Village of Biscayne Park

Agenda Item

**Subject: Agenda Item 6A
Agenda Item 6B**

**Log Cabin Landscaping
Rec Center Landscaping/Fencing**

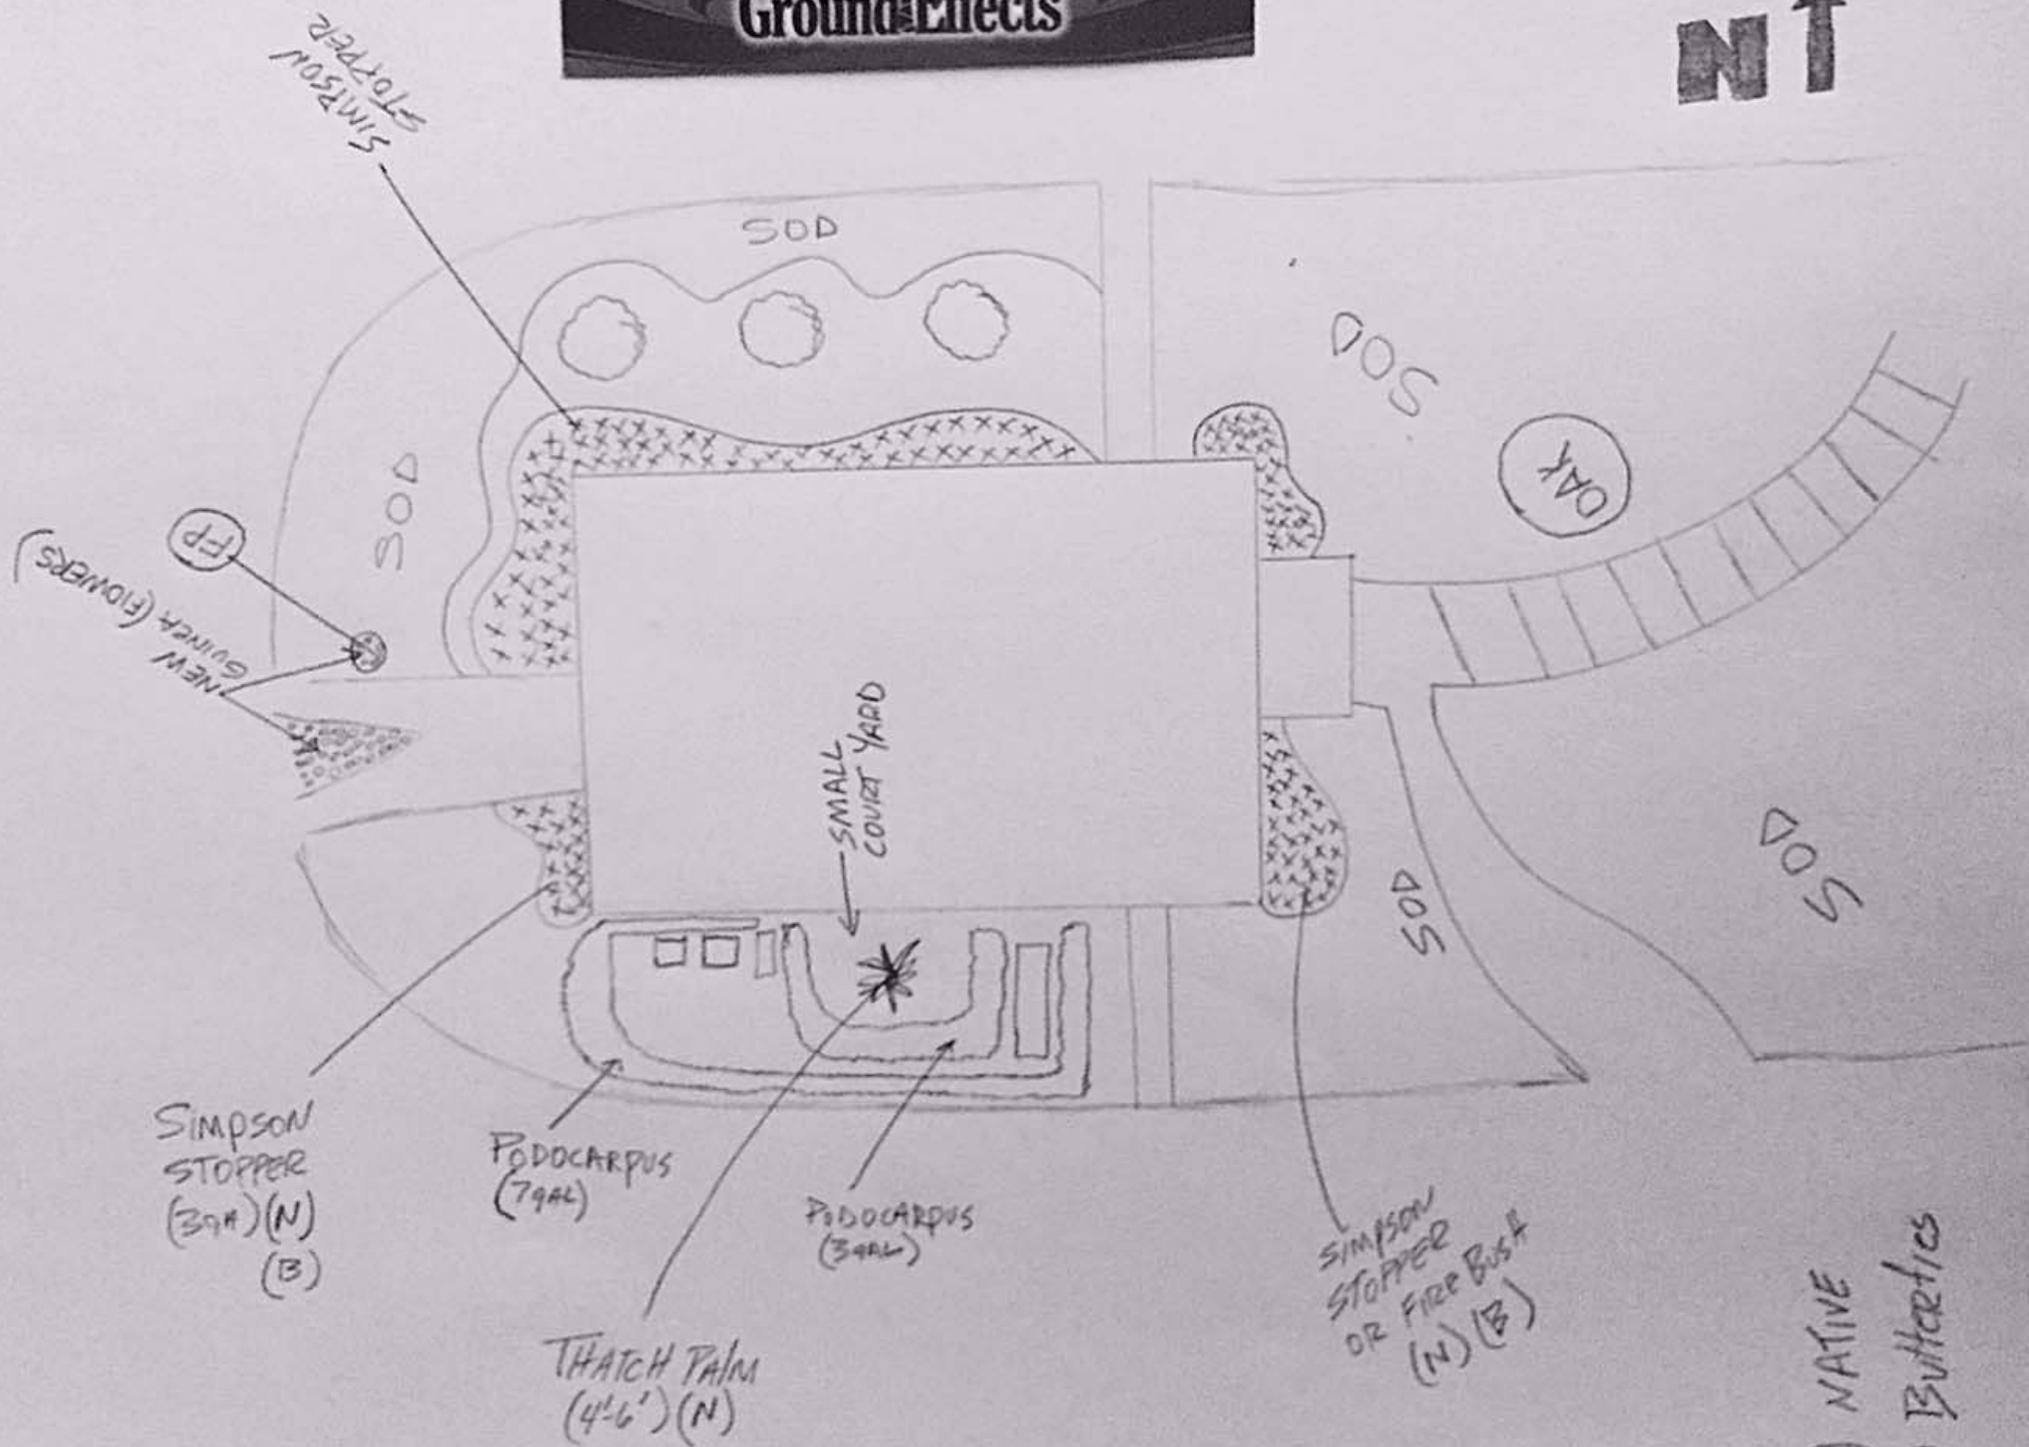
Attached is the sketch done by the landscaper we worked with on Village Hall. The direction I gave him was that we wanted to highlight the cabin, and use landscaping to disguise the mechanical section on the south side.

Heidi and I discussed the plan, and our only concern is that the small Simpson Stoppers around the edge of the cabin will cover part of the stone, which is being cleaned and refurbished. We'd like to lose those, thereby making the stone a visible feature as well.

This was a preliminary brainstorming just to get an idea on paper. He has not given me a price for this, but did the sketch to give us a starting point.
